Buckeye Union School District

E-RATE Year 22 (2019-2020) - 470 # 190019565

RFP #2019-1 Access Points

Addendum #1

Attachment No. 1 – Revised Blue Oak Map

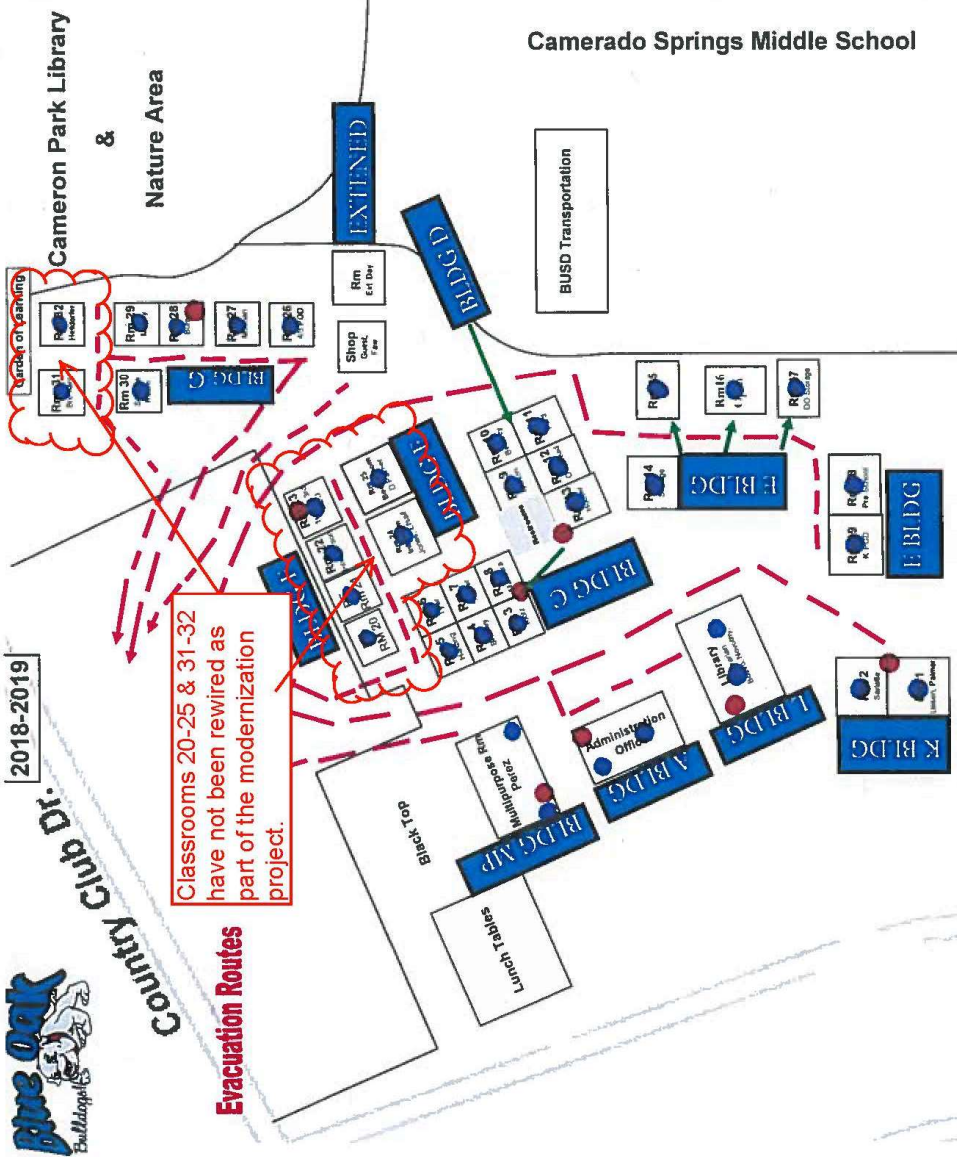
Q: Can you confirm what Category the Patch panels are in all the schools? Cat 5e or Cat 6? Special attention to the cable being reused possibly at Blue Oak also. If the new cable is Cat 5e, we could not reuse them. Just confirming.

Q: Can you confirm a pathway from building to building at Blue Oak (F – Building)?

A: BUSD has a variety of existing patch panels at the sites, CAT 5e and CAT 6. All existing patch panels will be reused regardless if they are CAT 5e or CAT 6. Existing cabling that can possibly be reused at Blue Oak is CAT 6. Please note that not all buildings at Blue Oak have existing CAT 6 cabling, and that the reuse of any cabling will be at the risk of the proposer. A revised map has been attached (**Attachment No. 1**) showing what classrooms at Blue Oak did not get rewired during the recent modernization project. BUSD can confirm that a pathway exists with sufficient room to allow for wiring the classrooms shown on the attached drawing.

A: It has been confirmed that a pathway exists between Classroom 23 and Classroom 25 at Blue Oak.
